Access Compliance Report

Public Rights-of-Way

(Curb Ramps)

Intersection ID: N/A	Main Street: POTOMAC_RIVER_PY	Cross Street: NATIONAL_AV	Location: N
ADA ID: 2D6750A20EB8	Ramp Type: Directional1	Initial Pass/Fail: Fail	Overall Compliance: No
Severity Score: 12.5			
Codes/Mitigation Info/Possible Solution		Field Measurements/Component Compliance

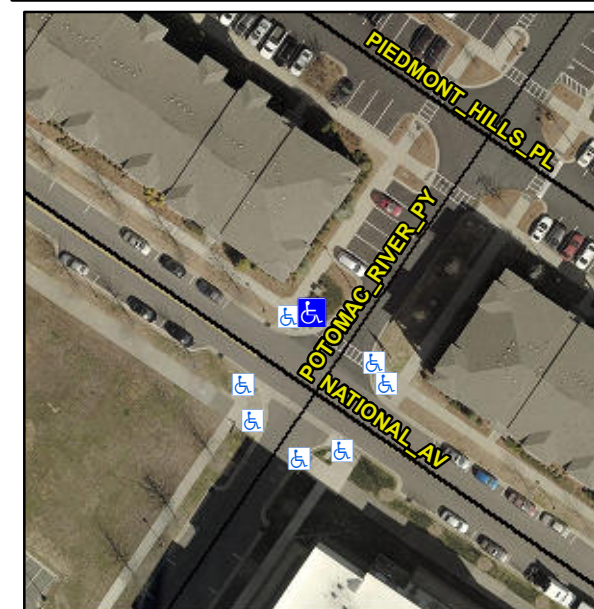
R304.5.3

Compliance	Description	Data	Compliance	Description	Data
N/A	Ramp Length (in)	63.5	N/A	Grade Break?	N/A
Yes	Ramp Width (in)	70.0	N/A	Grade Break Slope (%)	0.0
Yes	Ramp Slope (%)	0.7	N/A	Grade Break XSlope (%)	0.0
No	Ramp XSlope (%)	5.5			
N/A	Flare Type LT	N/A	N/A	Flare Type RT	N/A
N/A	Flare Slope LT (%)	N/A	N/A	Flare Slope RT (%)	0.0
N/A	Flare Traversable LT?	N/A	N/A	Flare Traversable RT?	N/A
N/A	Landing Length (in)	0.0	N/A	DWS Provided?	N/A
N/A	Landing Width (in)	0.0	N/A	DWS Contrast?	N/A
N/A	Landing Slope (%)	0.0	N/A	DWS Length (in)	N/A
N/A	Landing X Slope (%)	0.0	N/A	DWS Full Width?	N/A
N/A	Landing Curb? (Y/N)	N/A	N/A	DWS Offset LT (in)	N/A
N/A	Shared Landing?	N/A	N/A	DWS Offset RT (in)	N/A
N/A	Gutter Ponding?	0.0	N/A	Gutter Slope (%)	N/A
N/A	Gutter Lip Ht (in)	0.0	N/A	Gutter X Slope (%)	N/A
N/A	Painted X Walk1?	Yes		Road Slope (%)	4.1
	X Walk 1 Direction	To E		Road X Slope (%)	3.1
	X Walk 1 Width (in)	64.0		Clear Space?	N/A

Remove & Replace Entire Ramp.
